Certificate of Appropriateness

Property 2710 E. BELLEVIEW PL. North Point North HD
Description of work As drawn with conditions below.
Date issued 2/21/2022 PTS ID 115155 COA: LANDSCAPING (FEB 2022)

6 TYPICAL SECTION - MASONRY VENEER CONCRETE WALL

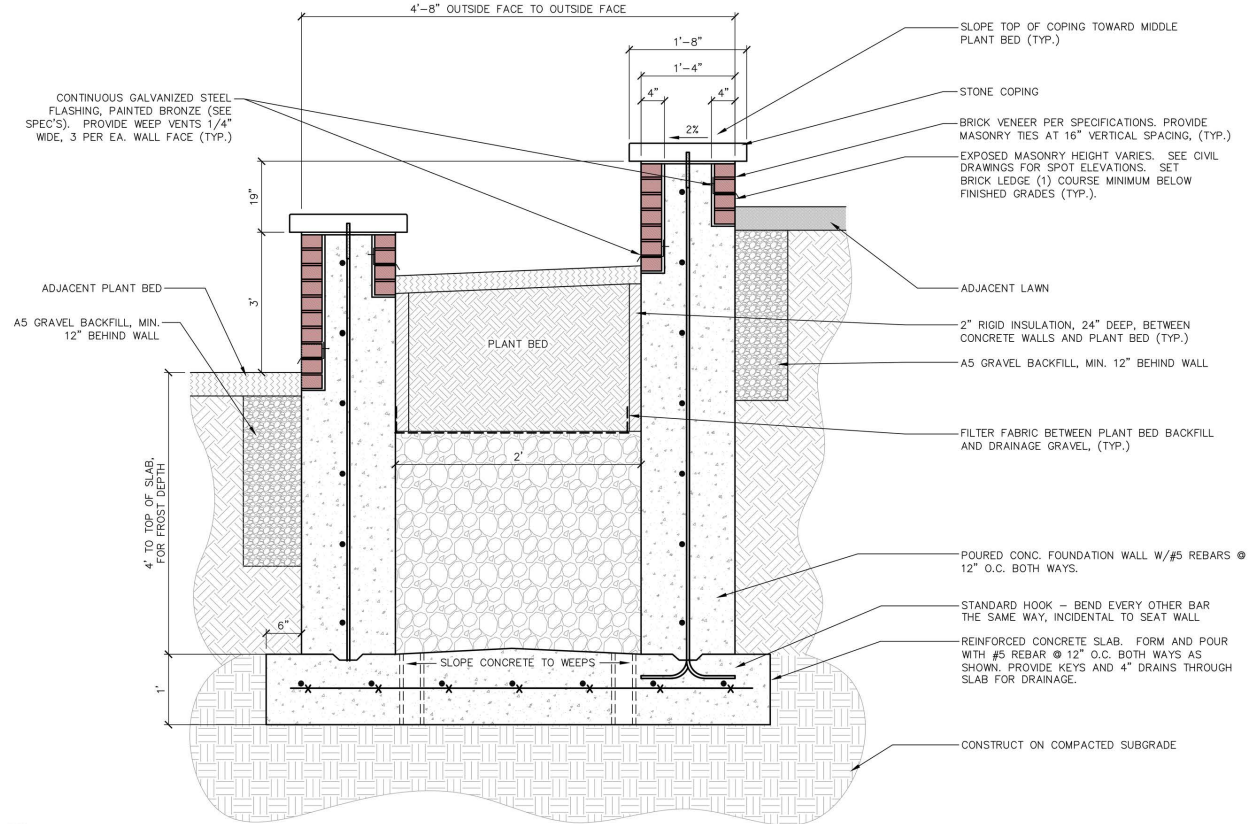
1. All work must be complete by August 1, 2022.
2. Existing concrete must be saw-cut for removal only. No jackhammers are permitted.
3. Bricks and jointing for new retaining wall must match the house as closely as possible.
